#### Regulation No. 107 (Construction of M<sub>2</sub> and M<sub>3</sub> vehicles) -

#### Proposals for further amendments

### Proposal for amendments to Regulation No. 107

#### Submitted by the expert from the International Organization of Motor Vehicle Manufacturers \*

“Figure 6:  
**Gangway Mannequin.**”

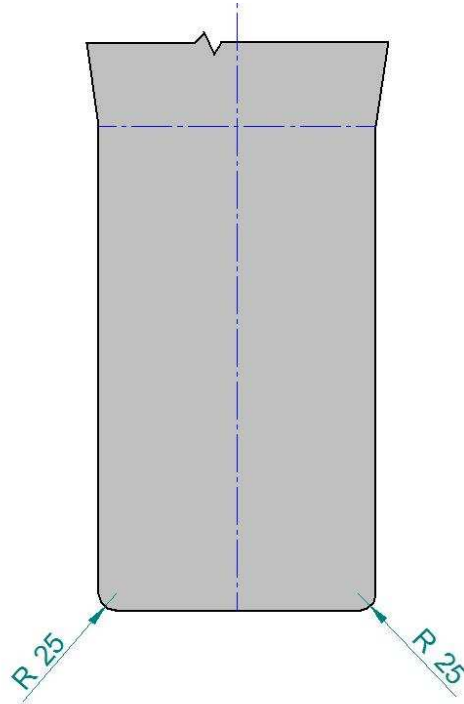
Annex 4, Figure 6, amend to read:

1. It is desirable to incorporate a “Clean-Easy” floor covering arrangement to reduce/eliminate dirt traps, e.g. by wrapping the gangway floor covering up onto seat bases/seat boxes/plinths; this creates a small radius at the transition from horizontal gangway floor covering to vertical seat base/box/plinths, thereby eliminating the dirt trap created at a square transition.

2. Existing Regulation No. 107 “Gangway Mannequin” has square transition from vertical to horizontal planes at its base, preventing “Clean-Easy” floor covering arrangement from being employed. Following the initial proposal (Informal document GRSG-98-10), comments returned suggested that 25mm radius would be more appropriate than the initially proposed 50mm at base of mannequin in order to allow “Clean-Easy” flooring.

3. The proposal is thus modified to reflect these views.
